DATE:	September 13, 2013	CO #:	13 (Thirteen)
TO:	Endeavor Construction Company 977 State Route 28 Milford, Ohio 45150	PROJECT:	Gallatin County Alternative School & Field House Gallatin County, Kentucky BG 12-133 RTA 0914
CONTRACT DATE:	December 5, 2012	CONTRACT FOR:	General Construction

Project:	<u>Gallatin Co - Alternative School</u>	Description:	<u>COR # 016</u>
Contractor:	<u>Endeavor Construction</u>		<u>PR #014 - Speaker Changes per</u>
Owner:	<u>Gallatin Co Board of Education</u>		<u>Owner's Request</u>
Architect:	<u>Ross Tarrant Architects</u>

PR #: Fourteen (14)

RE: Gallatin Co. Alternative School & Field House
Gallatin County, Kentucky
BG 12-133
RTA 0914

Press Box / Left side (1) Unit / Right side (1) Unit

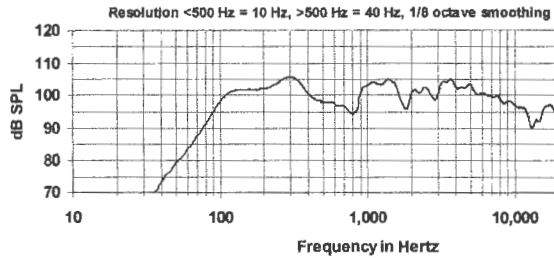
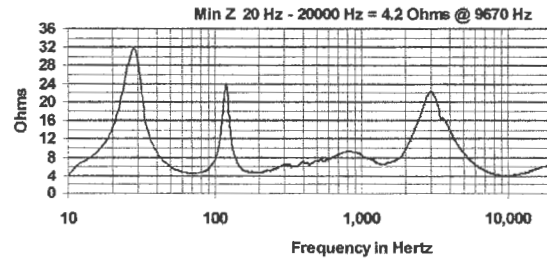
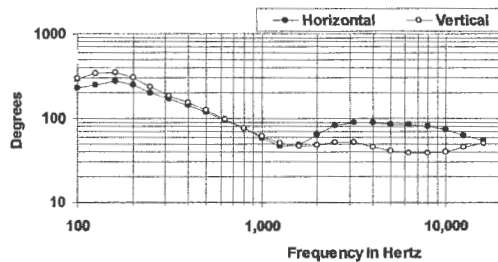
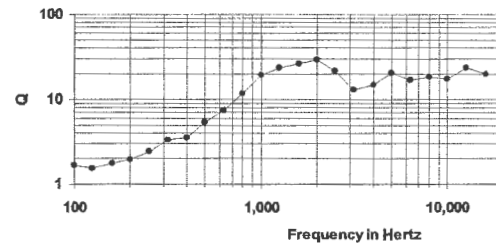
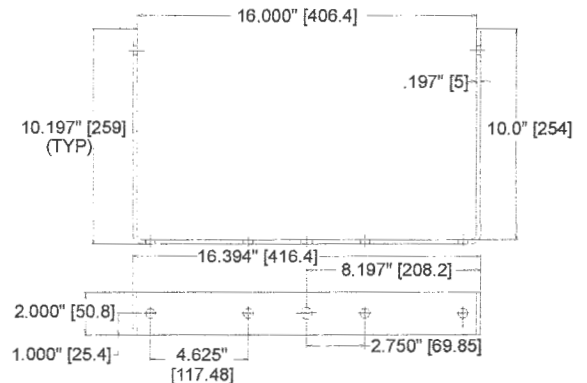
The Contractor is providing a material credit per the change order as requested by the Owner in Proposal Request 14 to adjust the speaker system to the football press box from the American Sound Community R2.0 speakers to the American Sound Community R0.5 speakers. A breakdown of the credit is attached for additional information.

Provide a material pricing adjustment to change the Community R2.0 speakers to the Community R0.5 speakers as recommended by American Sound, requested by the Owner, and reviewed by CMTA.

The R.5-94Z two-way, full-range loudspeaker system is engineered to provide quality full-range sound projection in a variety of outdoor and indoor applications. Its wide range, smooth frequency response and high efficiency ensure both high fidelity music reproduction and superb projection of clear intelligible speech with very low distortion. Five-year limited product warranty; fifteen-year enclosure warranty.
